Planning Commission Staff Report

Subject: Treasure
Project #: PL-08-00370
Authors: Francisco Astorga, AICP, Senior Planner
Date: 25 October 2017
Type of Item: Administrative – Conditional Use Permit
Refinement 17.2 Update

**TOWN LIFT MIDSTATION
& CREOLE SITE PLAN**
SWEENEY PROPERTIES MASTER PLAN

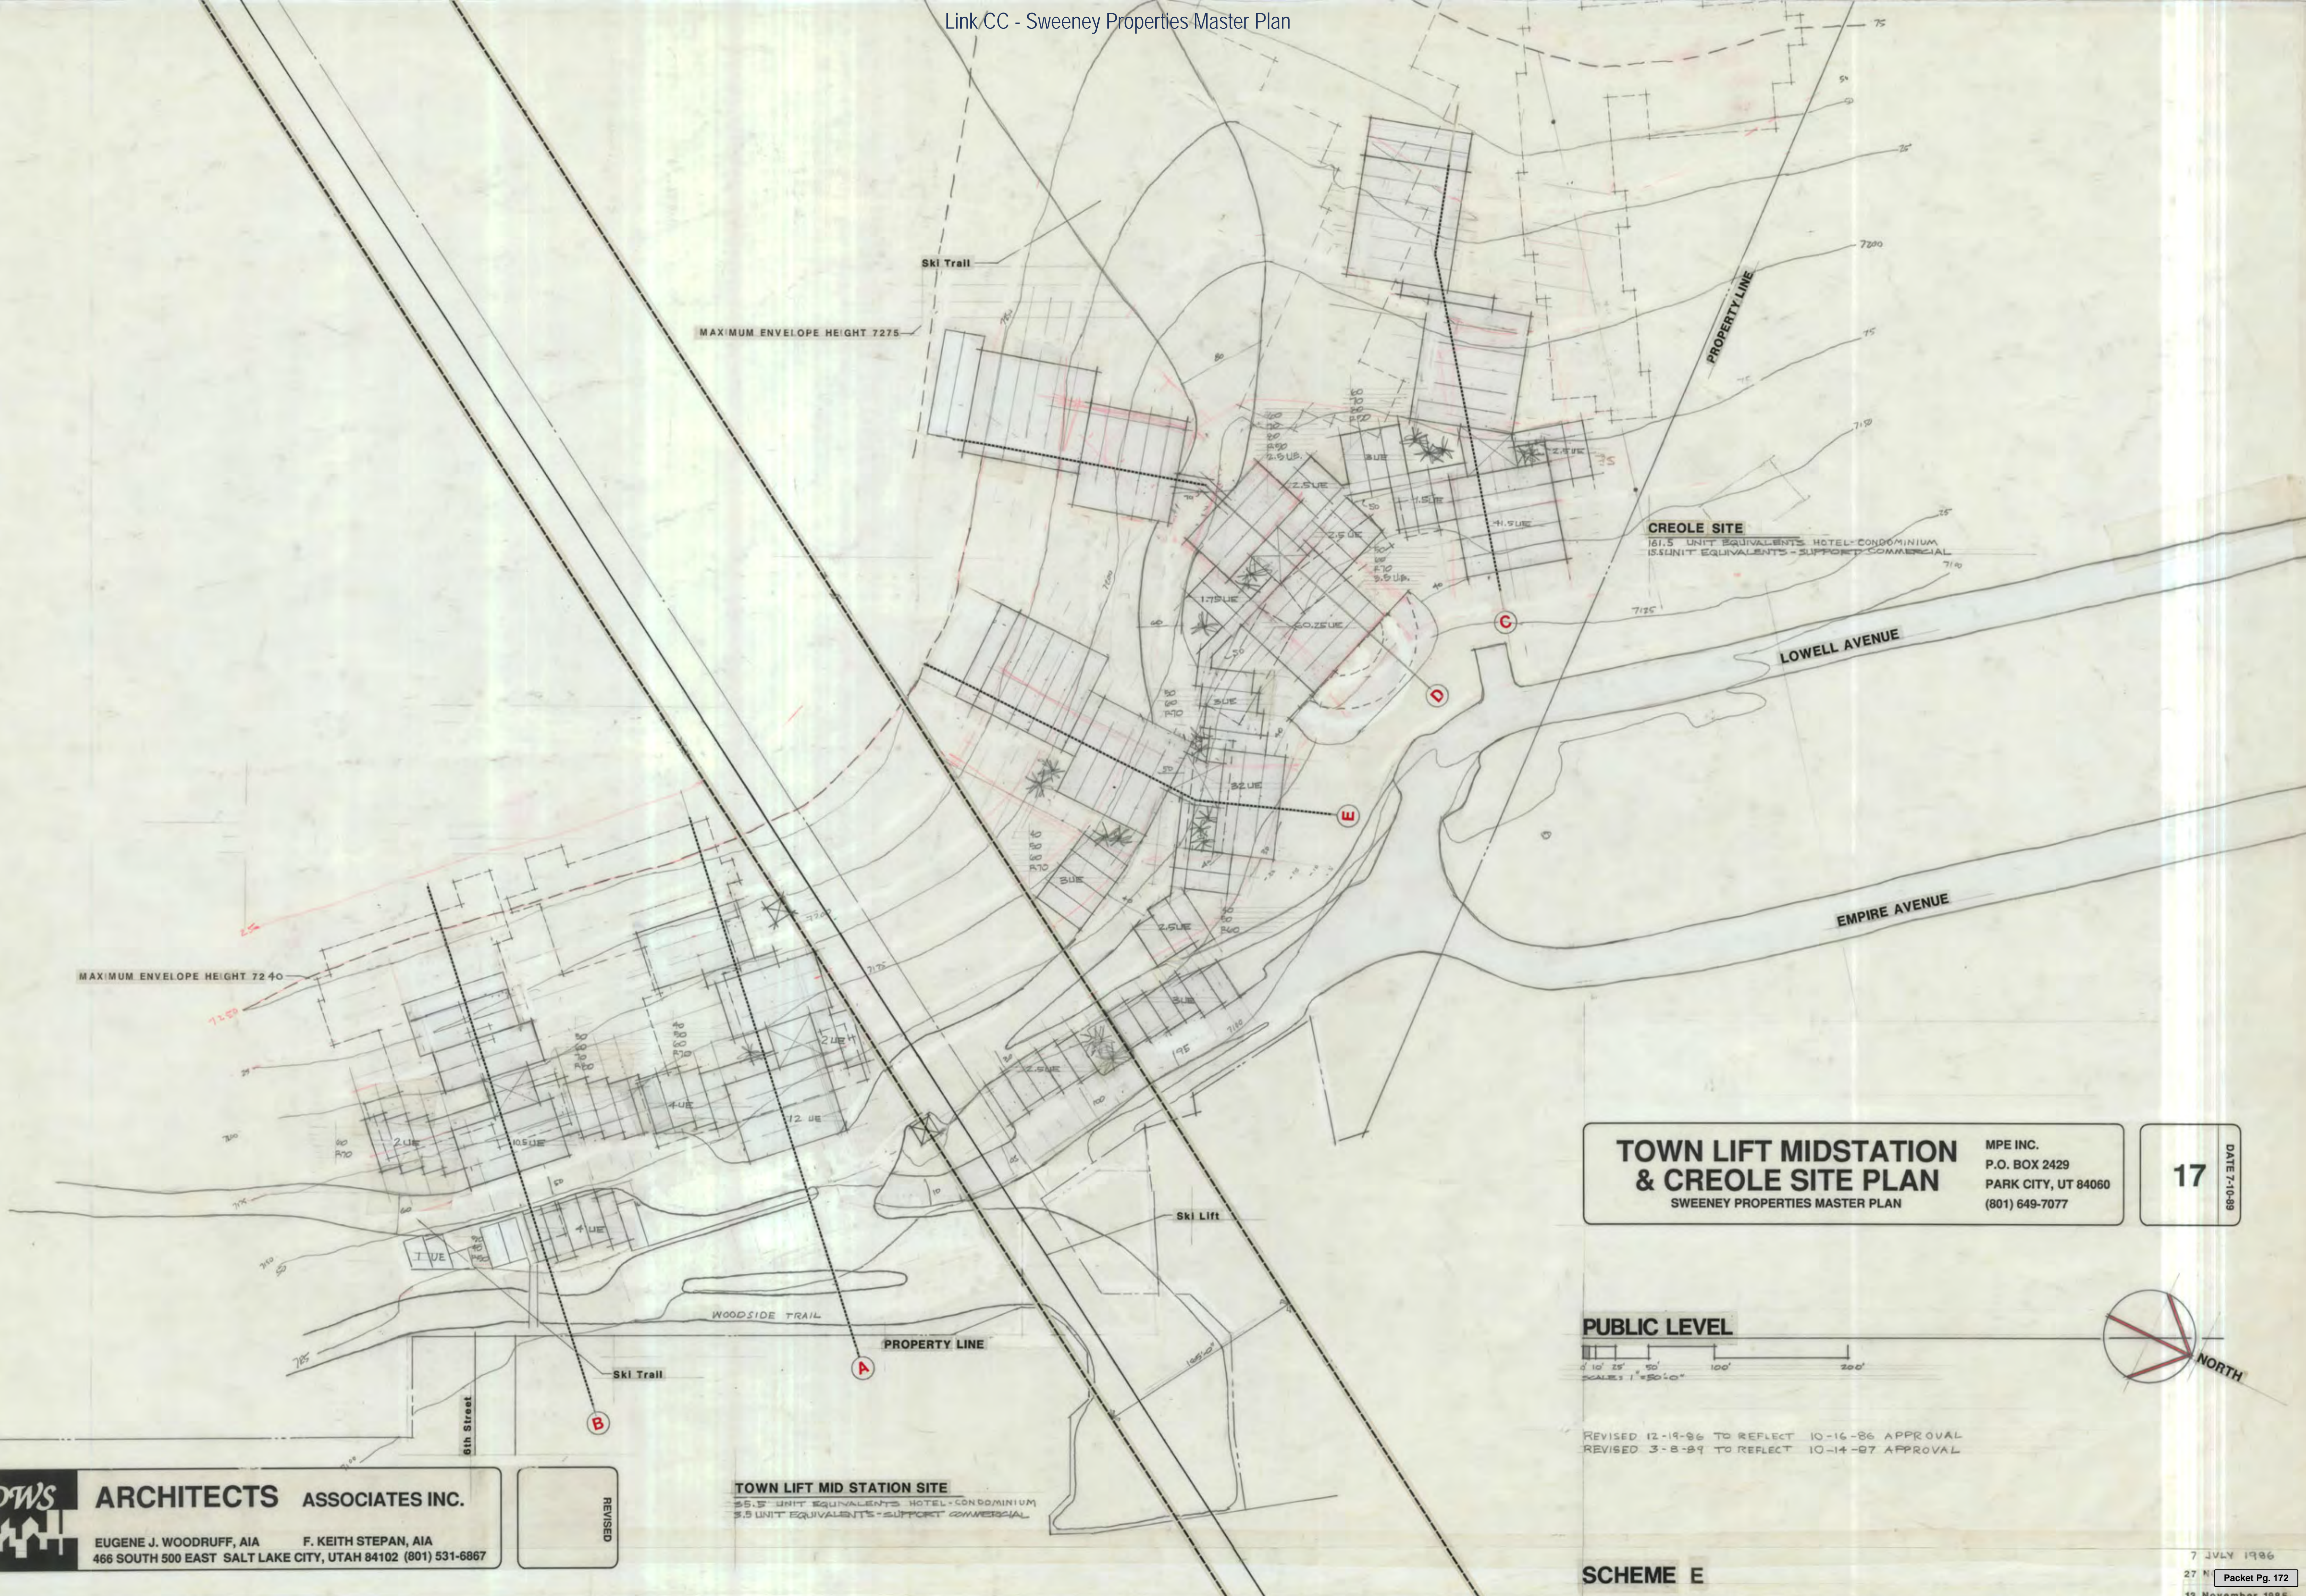
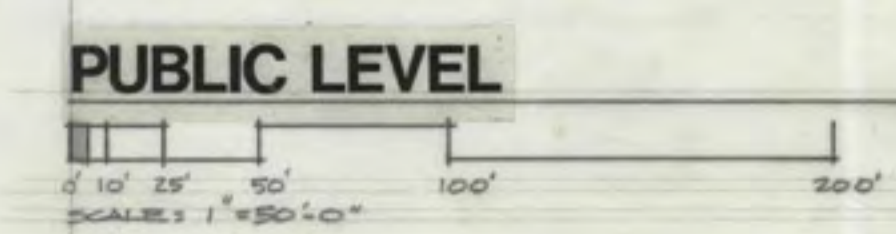
2. The various site plans show a series of buildings located at both identified sites.
3. Creole-Gulch site plans show a main building connected with 3 separate wings and 3 smaller buildings; see sheet 17.

4. Mid-Station site plans show a main building with 2 separate areas and two smaller buildings; see sheet 17.
5. Creole-Gulch site plans show the creole ski run running through 2 wings of the main building. Site plan sheet 22 has the following note: *“Where skit trail passes through building, opening to be a minimum of 40’-0” horizontal, 20’-0” vertical.”*

7. Both sites on sheet 17 (main site plan) show five (5) specified building sections. Building section A and B are within the Mid-Station site. Building section C, D, and E are within the Creole-Gulch site.
